5501XS, 5671XS & related tensioners

RENAULT 1,4 16V & 1,6 16V Petrol

Fig. 1

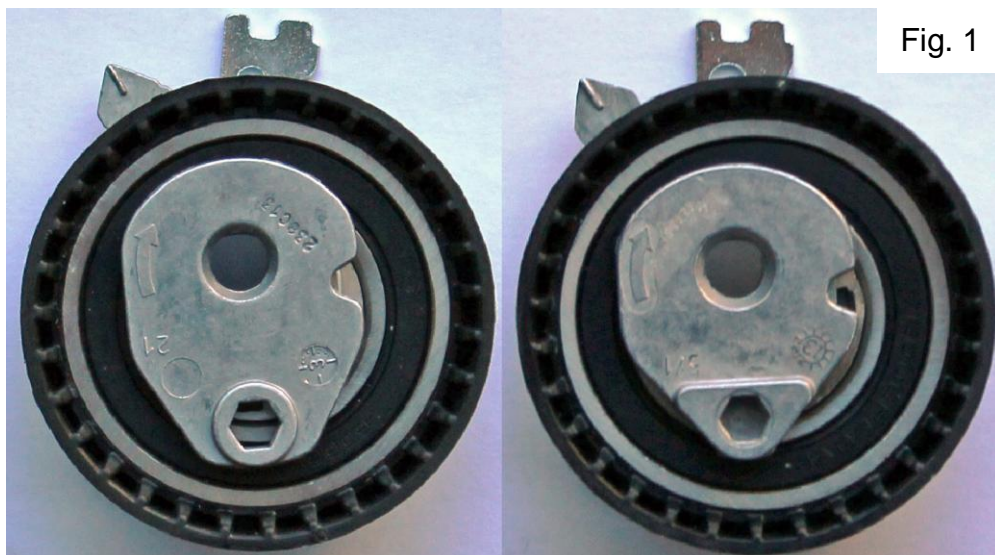
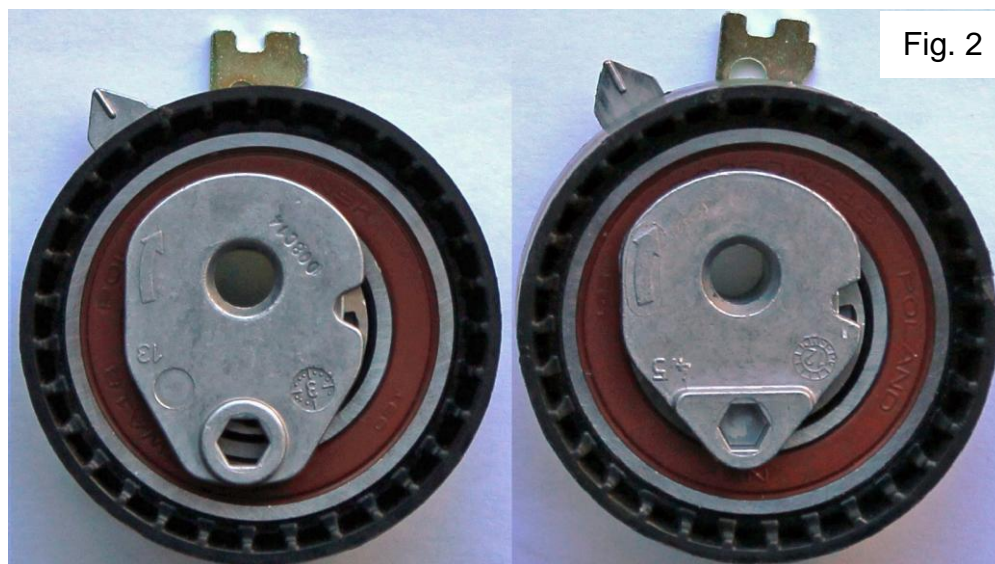
An OEM/OES upgrade has made timing belt 5501XS and the associated tensioners T43064 (Fig. 1 left) or T43168 (Fig. 1 right) as well as the related kits, obsolete. They will no longer be installed on Renault K4M/K4J engines.

Belt 5501XS has been superseded by 5671XS, tensioner T43064 has been superseded by T43236 (Fig. 2 left) and tensioner T43168 has been superseded by T43238 (Fig. 2 right).

All four tensioners appear to be identical, but there is an essential operational difference. New generation tensioners T43236 and T43238 deliver less belt tension and can only be used with the new generation belt: 5671XS, construction designed specifically for this upgrade.

The old belt (5501XS), old tensioners (T43064 and T43168) and kits from your inventory can still be installed on K4J/K4M applications manufactured before 2013. Old generation parts and new generation parts can't be mixed. The new belt (5671XS) may be used on all K4M/K4J applications. However, it must only be used in conjunction with the new generation tensioners (T43236 and T43238).
